Name of Board or Committee:	Zoning Board of Appeals
Date & Time of Meeting:	Thursday, February 16, 2023 at 7:00 p.m.
Location of Meeting:	Lakeville Public Library 4 Precinct Street, Lakeville, MA 02347
Clerk/Board Member posting notice:	Cathy Murray

A G E N D A

SUBJECT: Petition Review for K & J Doggy Palace – 330 Bedford Street

Town of Lakeville Zoning Board of Appeals
c/o Marc Resnick, Town Planner
Town of Lakeville
346 Bedford Street
Lakeville, Massachusetts 02347

LOTING SHEET

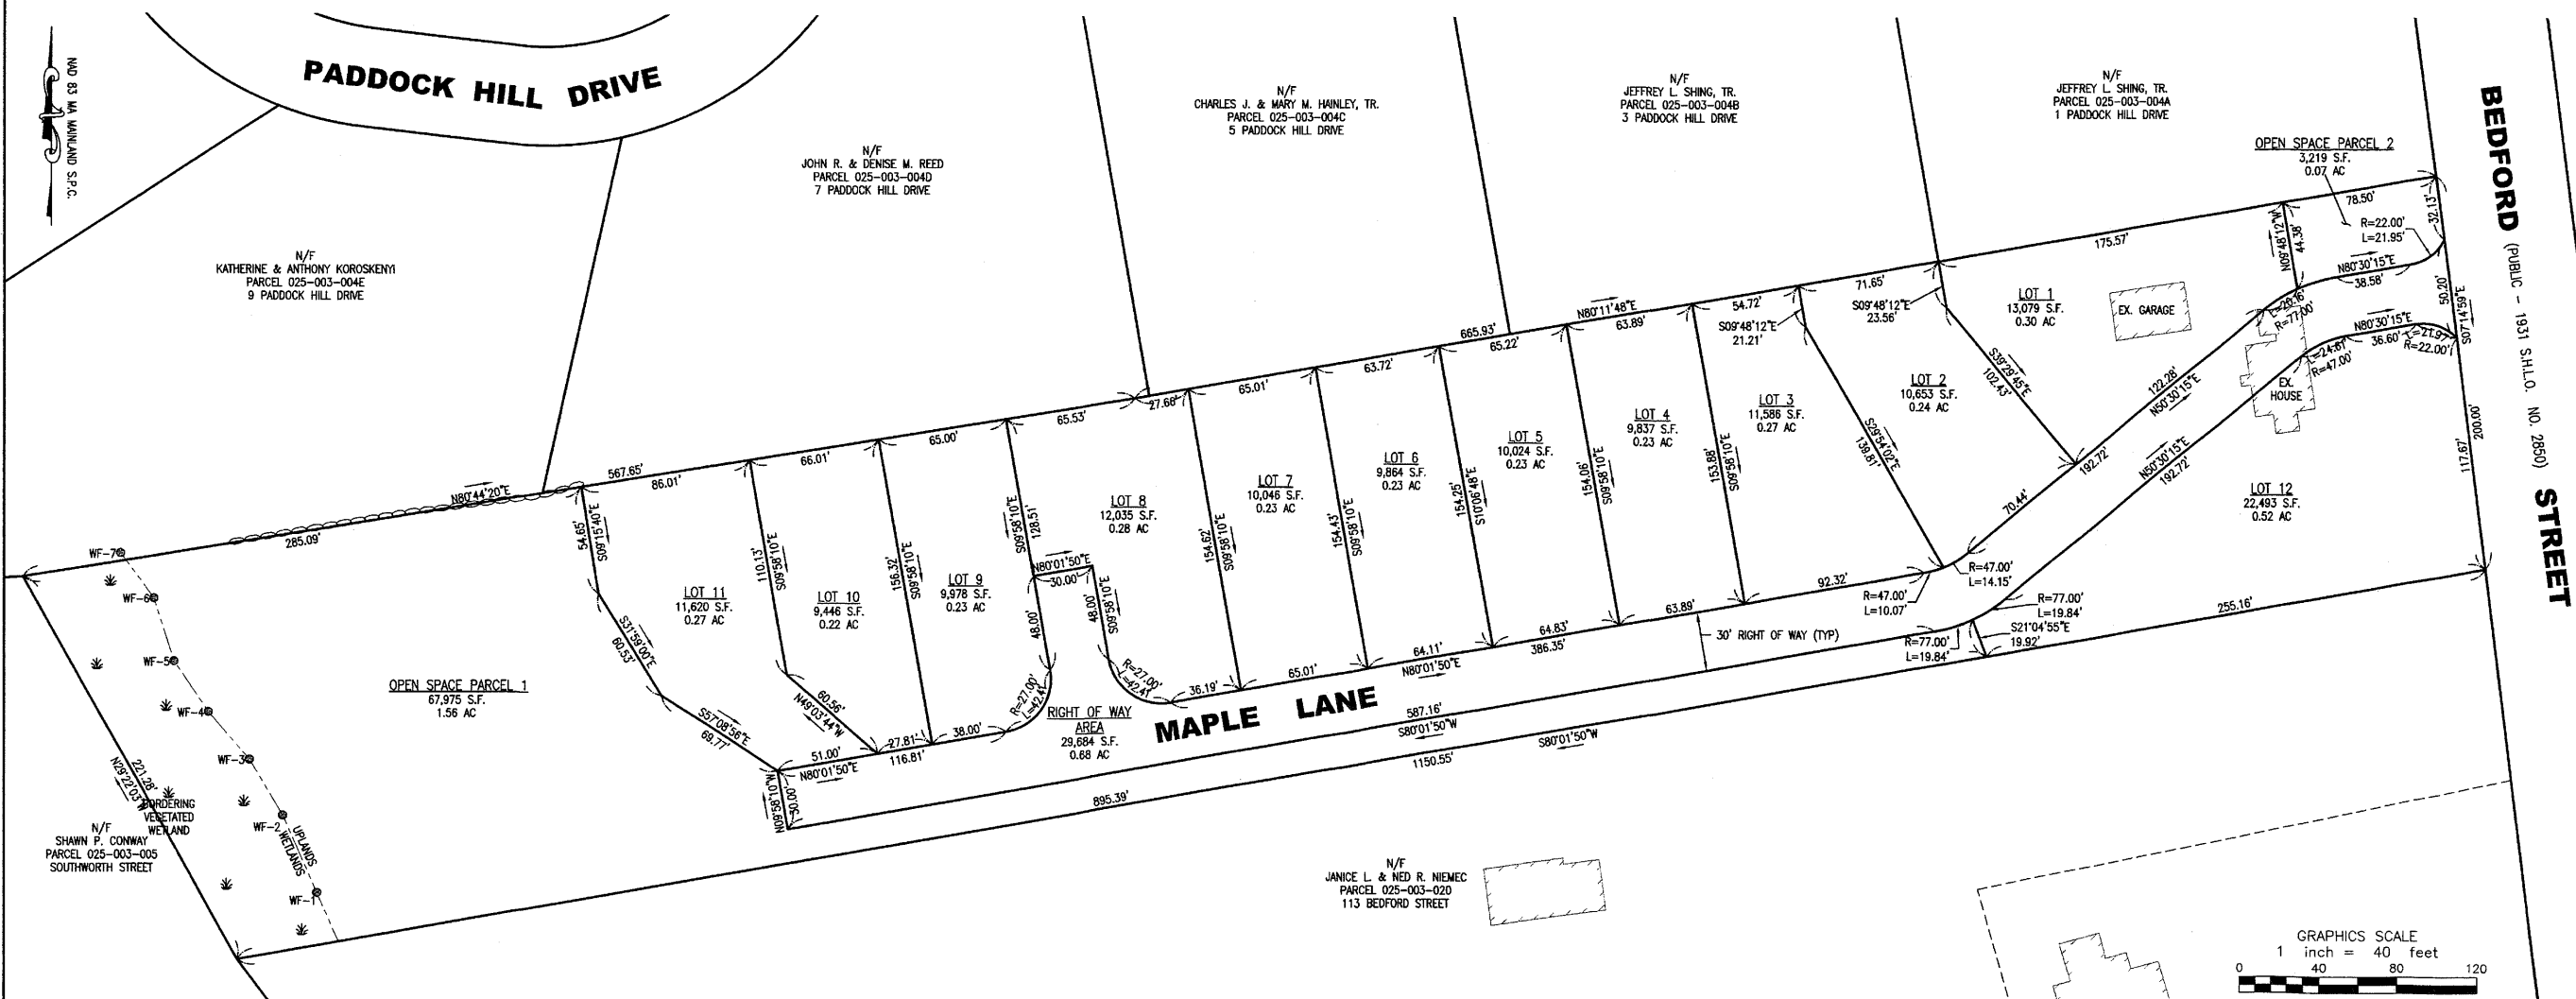
11. Monumentation to define lotting and property line limits does not appear to be included in the submission. We recommend that as a potential condition of approval that the Board consider that the Applicant provide typical monumentation.

LANDSCAPING PLAN
109 BEDFORD STREET
LAKEVILLE, MASSACHUSETTS
NORTH BEDFORD CROSSING LLC,
1 LAKEVILLE BUSINESS PARK DRIVE
LAKEVILLE, MASSACHUSETTS

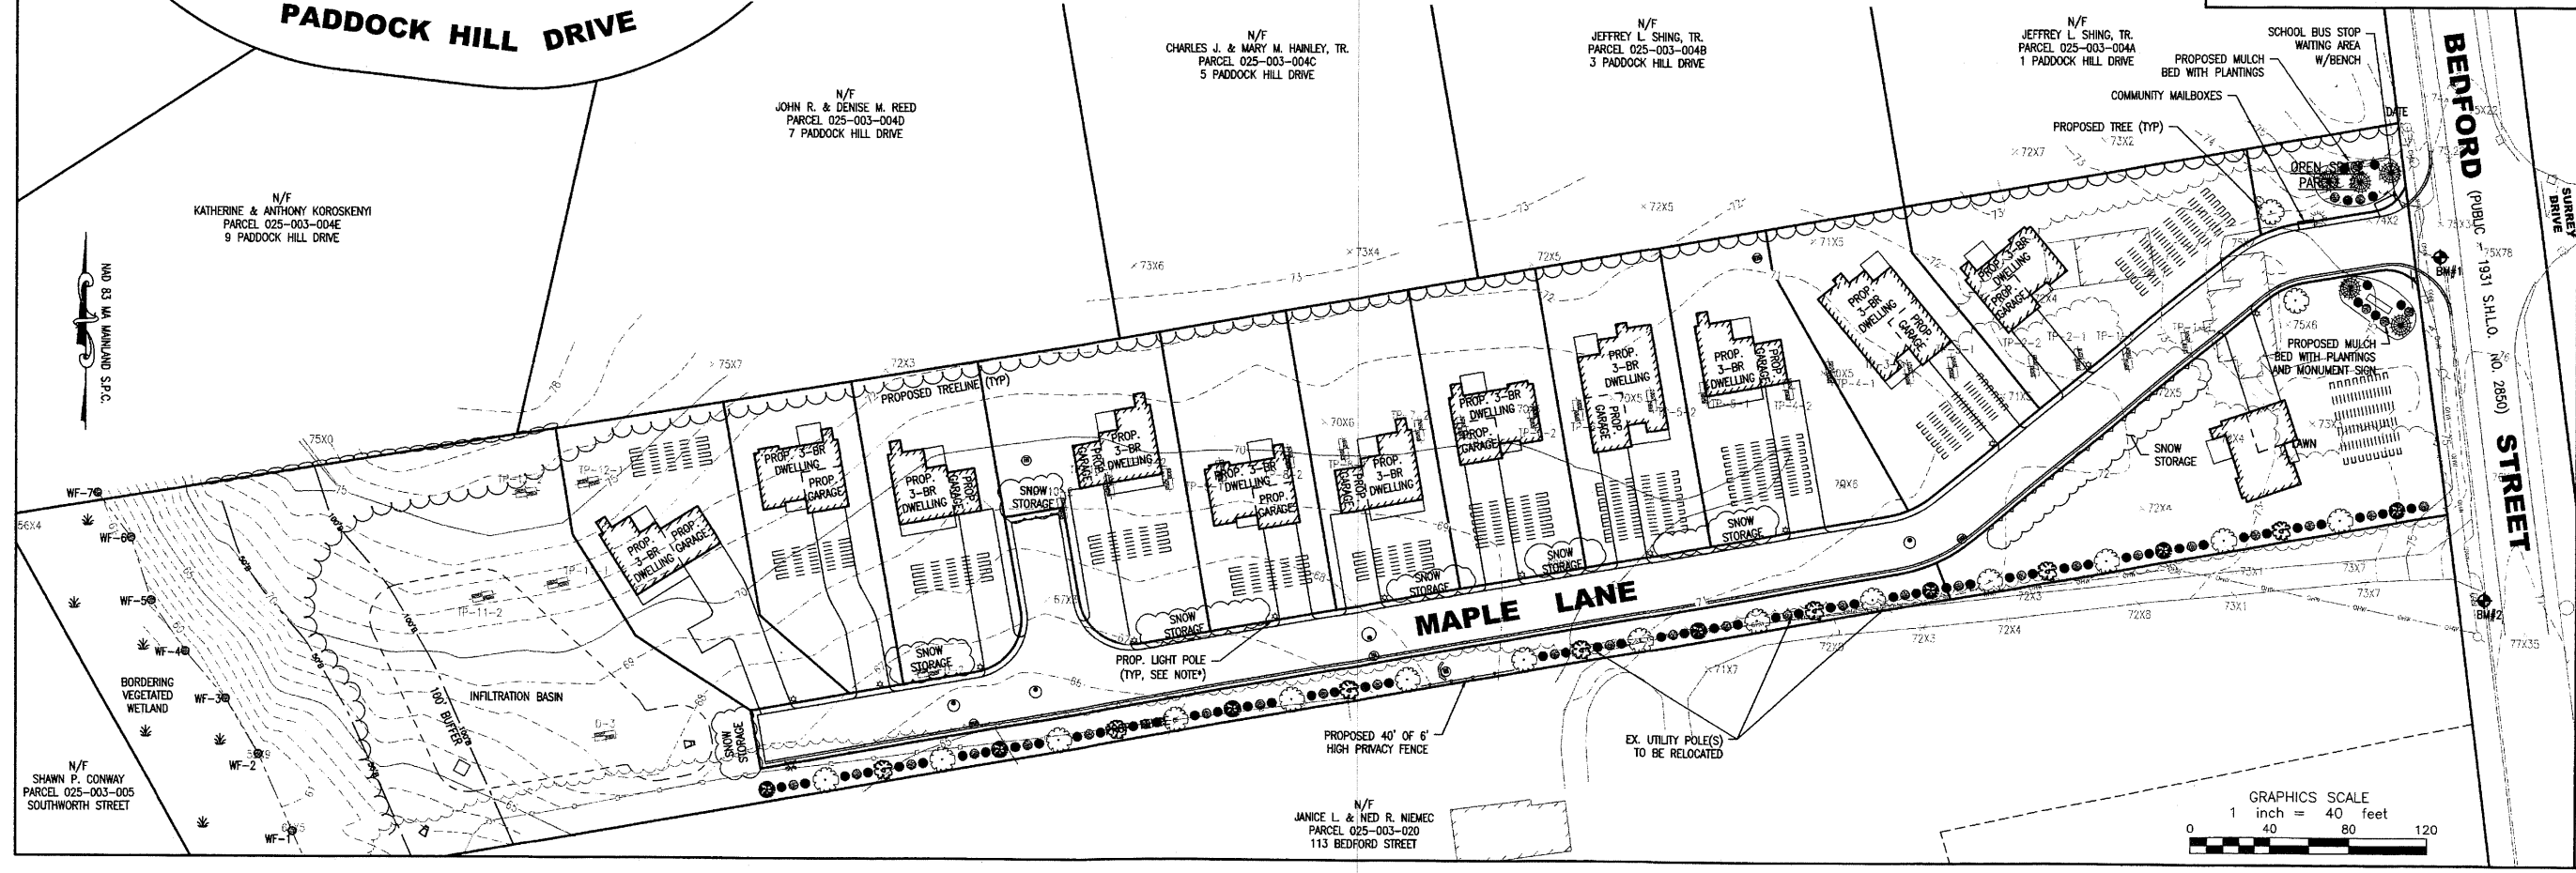
17. The Applicant has not proposed deciduous trees every 40' on each side of the subdivision road as required by Section IV.K.1 of the Regulations. The proposed plan does include a single row of plantings consisting of deciduous trees as well as small shrubs, and a 40' long section of 6' high privacy fence along the southern edge of the property, presumably to screen the development from the abutting property. We recommend that the proposed plantings be revised to include a variety of large evergreen trees and shrubs, supplemented with fencing where necessary to provide the intended screening.

18. The Typical Unit Landscaping Detail appears to be rather sparse. We recommend additional plantings be included in the plan to provide separation/screening between lots and plantings between the roadway and houses to provide visual interest along the northern side of the road.
